Value Engineering Study

Final Report

Kentucky Transportation Cabinet I-71 Widening, MP 14.1 to MP 18.0 Oldham County

Item No. 5-483.10

VALUE ENGINEERING PROPOSAL NO. 9

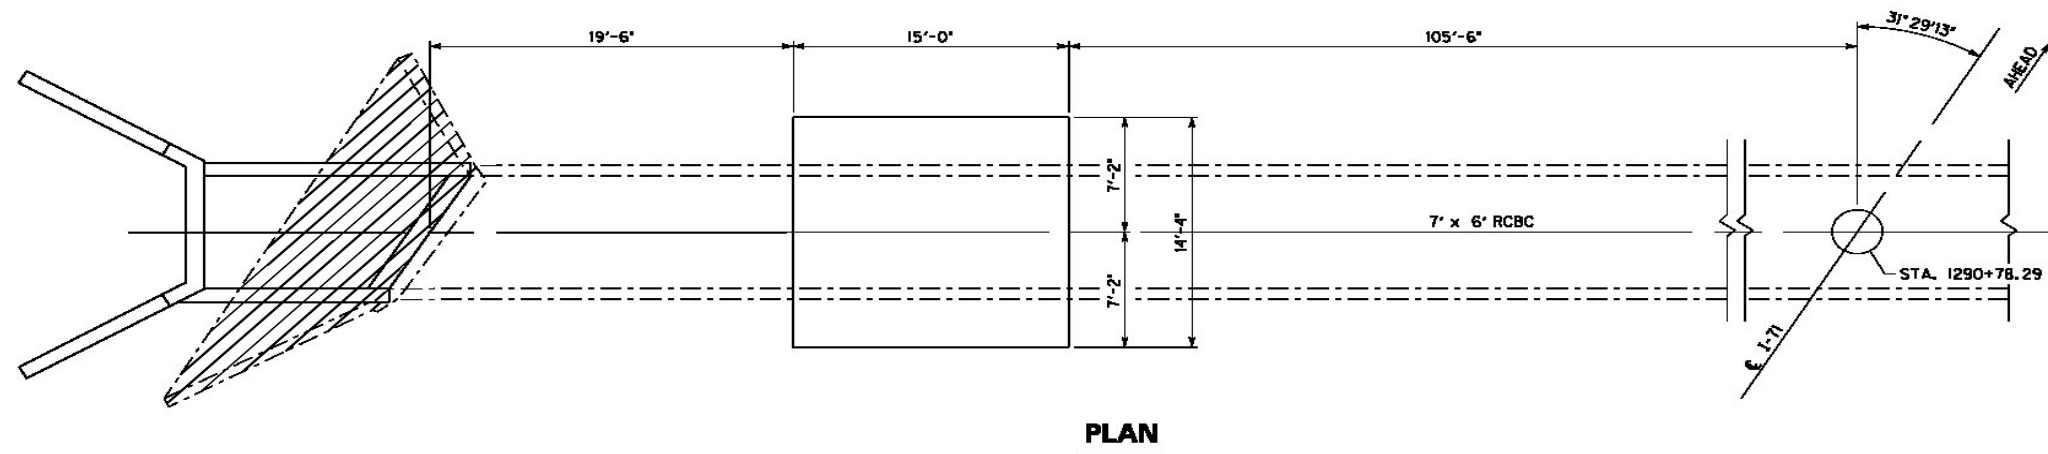
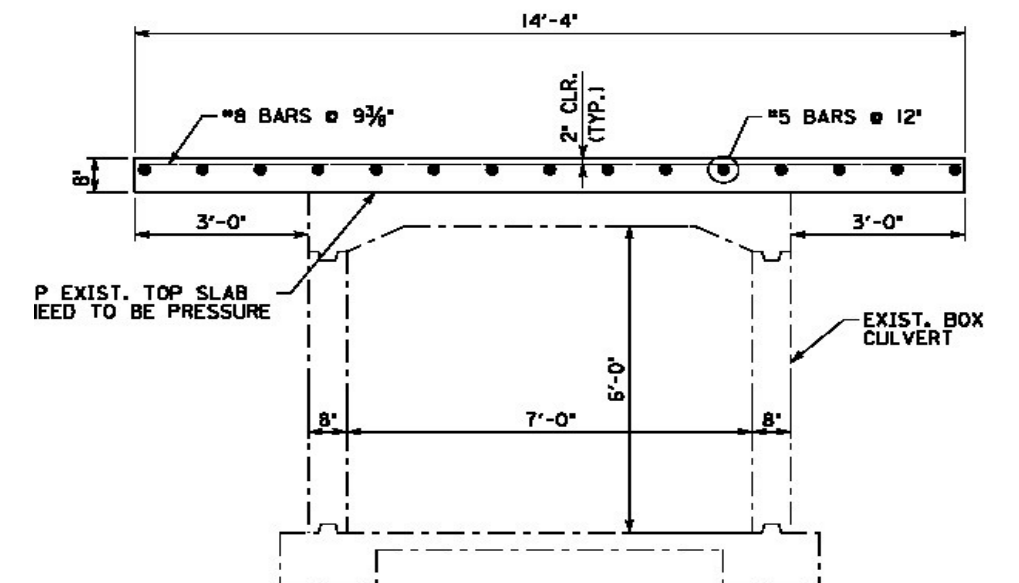
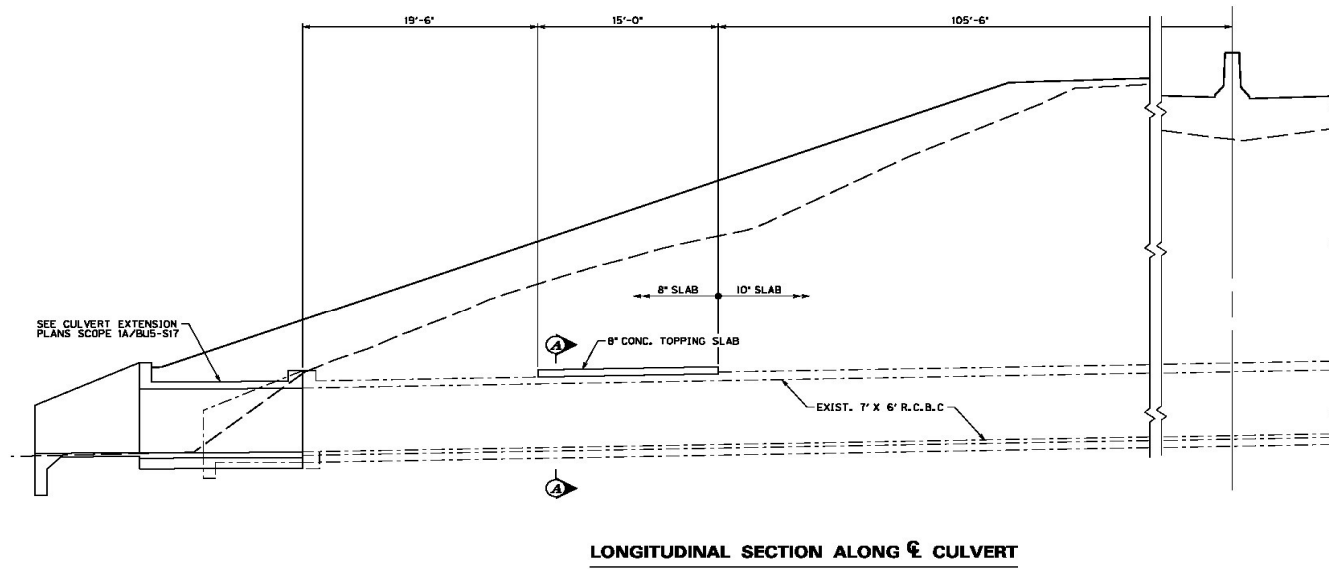
TITLE		Pour concrete on top of the existing culvert slab in lieu of placing lightweight material					
FUNCTION		Miscellaneous					
VE PROPOSAL SYNOPSIS:							
For I-71 step down culverts to be extended due to the roadway widening, place additional concrete and steel to reinforce existing culvert top slab in lieu of light weight fill material.							
	Reliability	Maintained		Functionality	Maintained	\$ Initial Cost Avoidance (Add)	
	O&M	Maintained		Schedule Impact	Improved		\$1,343,000
BASELINE CONCEPT DESCRIPTION:							
Based on the cost estimate for the project, light weight fill is to be used to address additional loading to be applied to existing step down culverts that are extended as part of the roadway widening.							
VE PROPOSAL DESCRIPTION:							
Place additional concrete and steel to reinforce existing culvert top step down slab in lieu of light weight fill material.							
VE PROPOSAL ADVANTAGES:			VE PROPOSAL DISADVANTAGES:

There is no baseline sketch for the culvert extension detail provided with the documents. This level of detail really is a final design item. However, from the VE team review of the cost estimates, it appears the project team intended to use lightweight fill for the culvert extensions due to the thinner top and wall sections of the existing culverts on the ends. The VE Team believes that it will be more economical to reinforce the culvert per the "Proposed" detail provided. If there is some question about the cost, as detailed in the VE proposal, the VE suggests that KYTC consider bidding alternates for this and let contractor price out best way to accomplish this item.

The value proposal is to consider doing a culvert top slab modification via placing additional concrete and steel to reinforce the existing top slab such that it will meet loading requirements from conventional fill. Minimal additional earthwork is anticipated for this operation, since it is necessary to expose the existing culvert top with the baseline option or the value proposal. Further, the culvert top reinforcement potentially eliminates the need for a specialty material supplier or possibly a specialty sub-contractor needed to place the light weight fill, thus limiting construction costs.

TITLE Reduce vertical clearance on KY 329 from 16' to 14'-6"

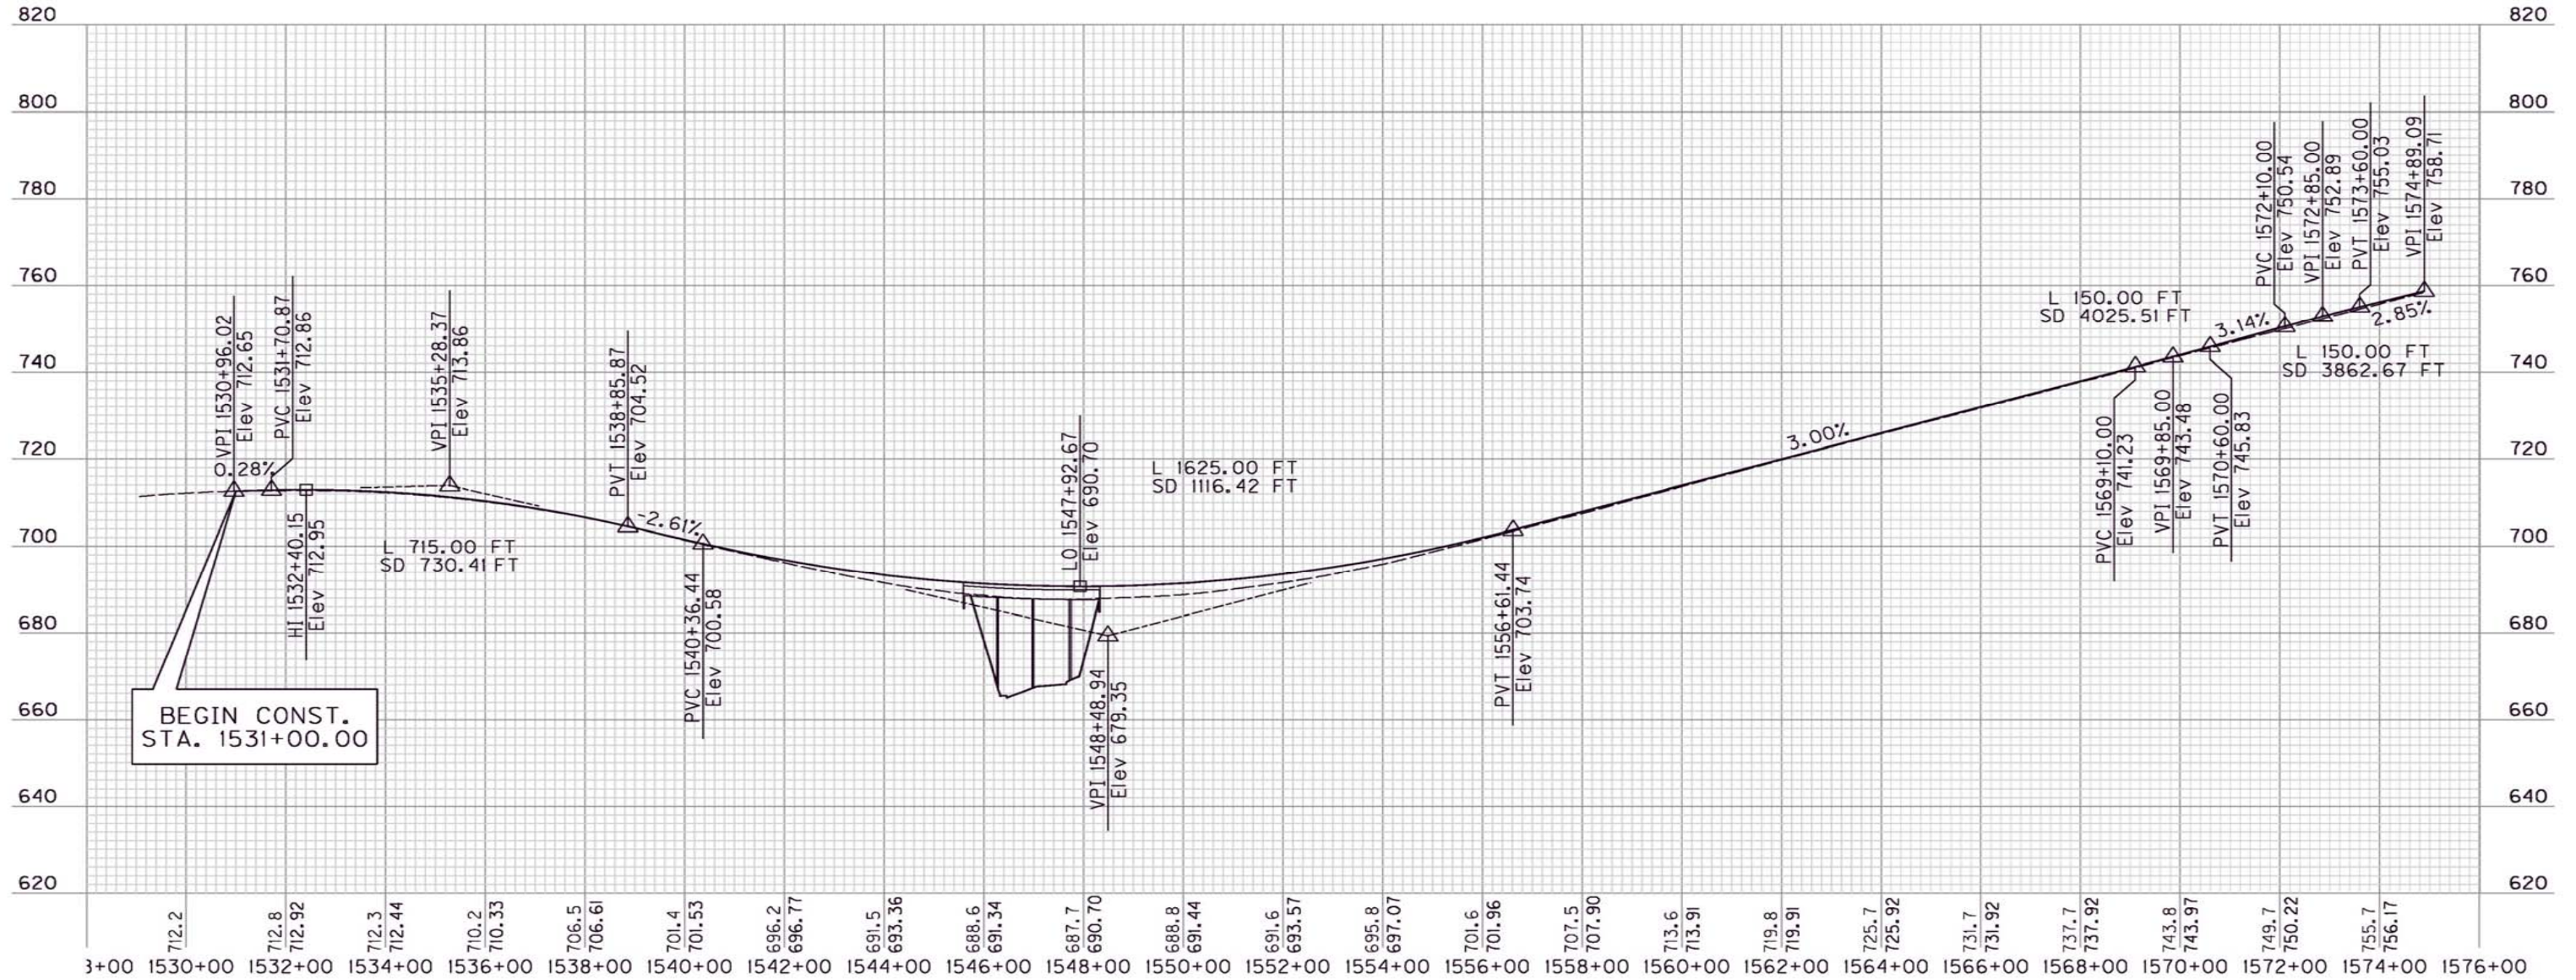
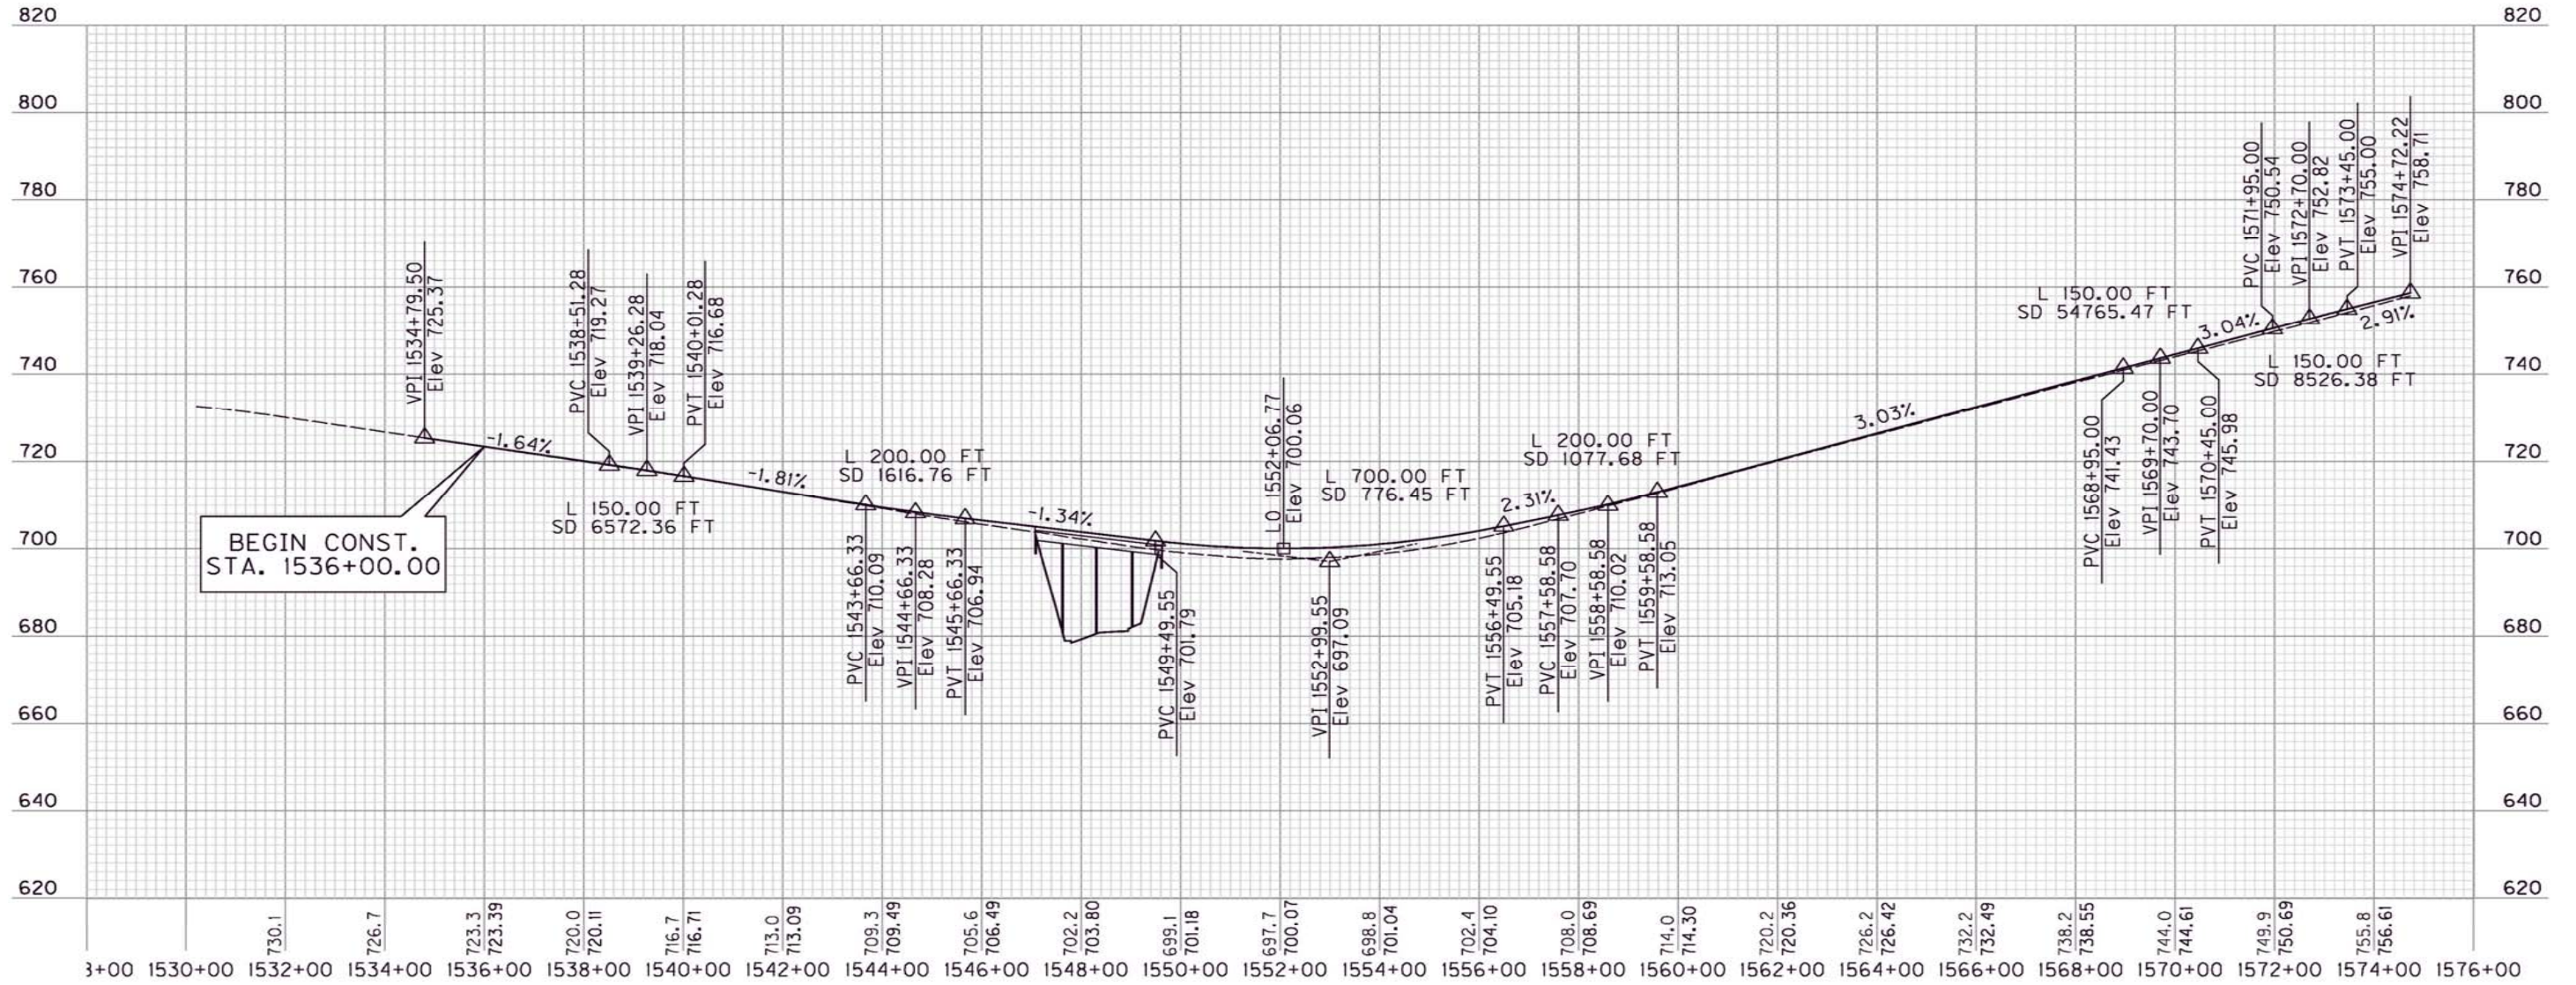
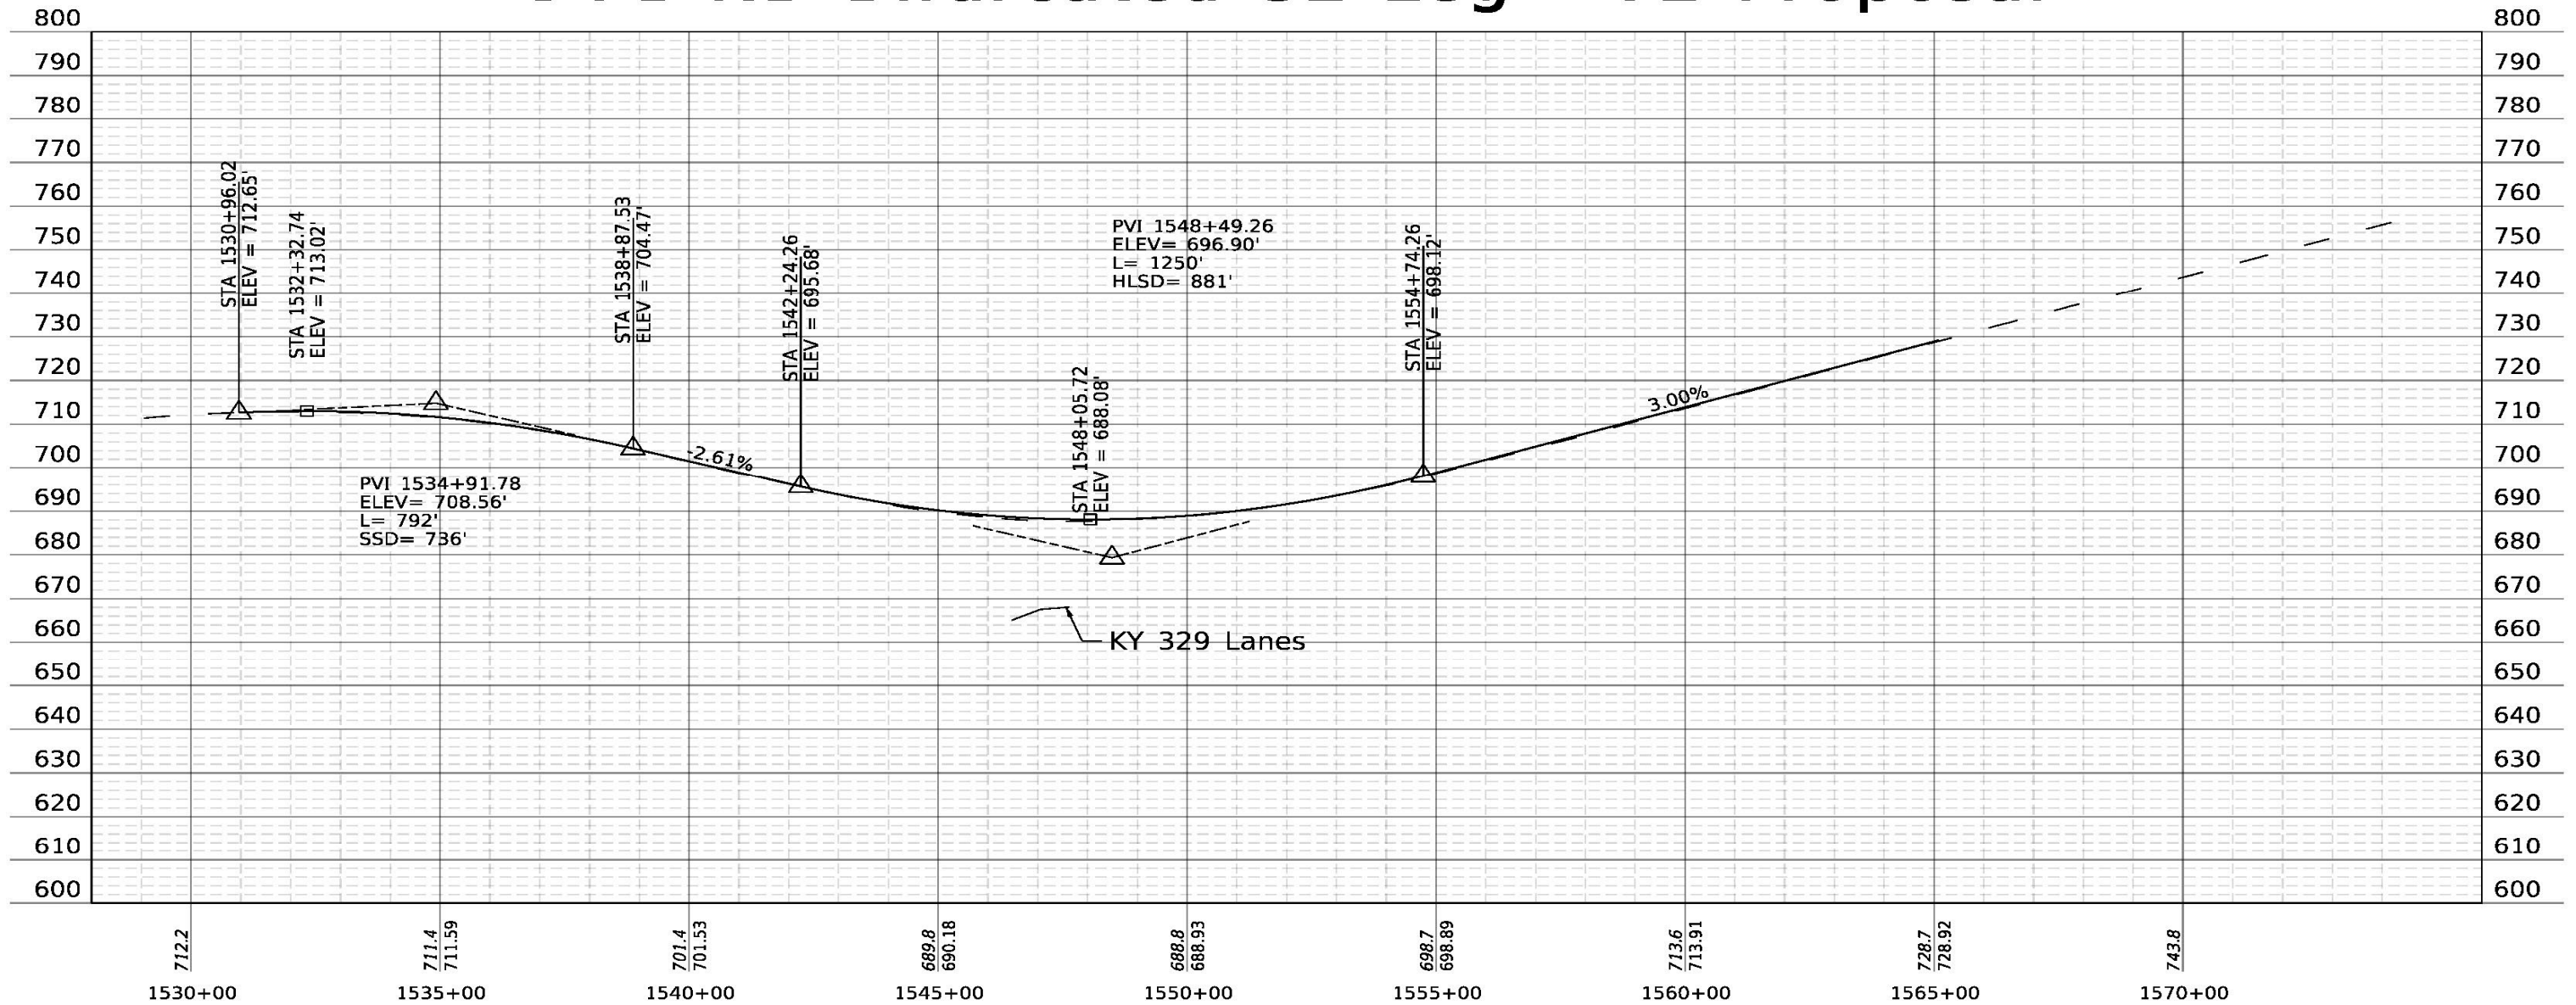
TITLE		Reduce vertical clearance on KY 329 from 16' to 14'-6"			
FUNCTION		Miscellaneous			
VE PROPOSAL SYNOPSIS:					
KYTC policy allows for routes not on an interstate highway and not on the Strategic Highway Network to have bridge clearances as low as 14.5'. Eliminate the grade revision on I-71 meant to achieve 16.5' clearance on KY 329 and instead widen near existing grade to achieve 14.5' allowed by KYTC.					
	Reliability	Maintained		Functionality	\$ Initial Cost Avoidance (Add)
	O&M	Maintained		Schedule Impact	
BASELINE CONCEPT DESCRIPTION:					
Adjust grade of bifurcated section of I-71 at the interchange with KY 329 to achieve a desired 16.5' vertical clearance at the bridge over KY 329.					
VE PROPOSAL DESCRIPTION:					
VE PROPOSAL ADVANTAGES:			VE PROPOSAL DISADVANTAGES:		
● Simplifies maintenance of traffic			● Lower bridge clearance		
● Reduces leveling and wedging need			●		
● Reduces embankment needed			●

The baseline design proposes to improve the sag vertical curves on I-71 at KY 329 to provide 16.5' of clearance on KY 329. The current clearance on KY 329 is 13.5' with haunched girder bridges carrying I-71 over KY 329. The value team proposes to reduce this clearance to 14.5'.

By reducing the proposed clearance, the constructability of mainline I-71 will be improved. The current baseline may prove difficult to maintain traffic on existing I-71 while raising the grade by 3'-4'. By reducing the amount of grade difference, the amount of shift needed to construct the new bridge is decreased. This will also reduce the total amount of pavement structure needed over the existing I-71 travel lanes to construct the grade change. It was unclear what material was being used to accomplish this grade change over the existing pavement. An assumption was made, based on the CAD files provided, that asphalt level and wedge would be utilized. By reducing the amount of grade change, a cost savings of over \$1,250,000 can be realized.

It also appears the proposed bridges on I-71 are wider than necessary to accommodate MOT in later phases when traffic is shifted onto the newly constructed bridge and approaches and work begins to complete construction of the new bridge and raise the existing lanes to the final grade. Additionally, the reduction of grade change will greatly simplify MOT schemes and provide additional cost savings that can be realized but are difficult to quantify in this proposal. MOT savings have not been included in this proposal.
